Re: Corazon Santo Subdivision/Homewise Inc.; Construction Stormwater; SIC 1522; NPDES Compliance Evaluation Inspection; NPDES # NMR1000BN; November 16, 2017

NPDES Cons	struct	tion Genera	ıl Permit Insp	ection Rep	ort – Stat	e of New M	lexico
Inspection Date	11/16/2017 Entry Time 1110						
•			Exit	Time		1315	
Inspector Name/	Dani	iel Valenta –	(505) 827-2575	,			
Telephone							
Facility Name/	Cora	azon Santo S	ubdivision/2736	6-2738 Agua	Fria Street	, Santa Fe, I	New Mexico
Physical Location				_			
Facility Type	☐ Commercial ☐ Residential ☐ Municipal ☐ Ir				Industrial		
County Location	Inty Location Santa Fe County						
Latitude/Longitude 35° 39' 54"/-			° 39' 54"/-105° 59' 26"				
(Decimal Degrees)							
		Date			NPDES	NOI Cert	
Operator/Mailing Address		Company	Authorized	Phone	Tracking	Date	SWPPP
		Operation	Official(s)	FIIONE	Number	Date	Cert Date
		Began			Number		
Hamanila a Jana 1001		40/0/0047	Dialoguel Cilve	FOF 70F	NIMPAO	N 4 O	A 4 A C

Photo # 1

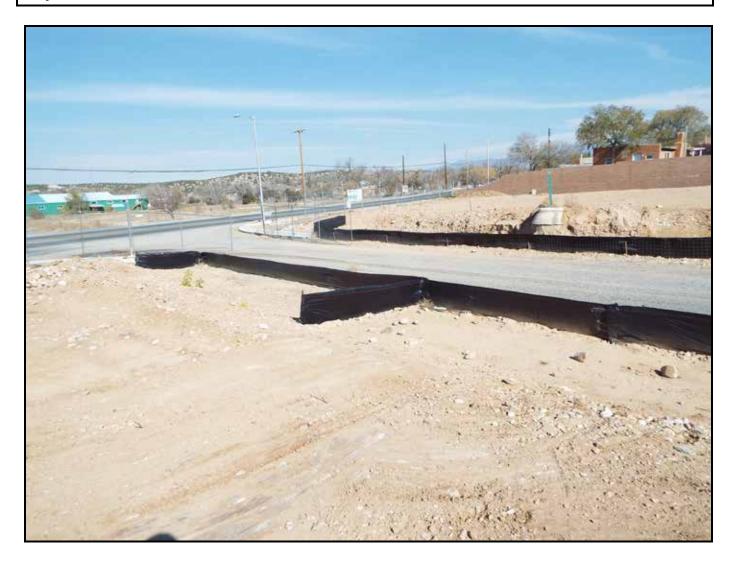
Subject: Entrance to site.
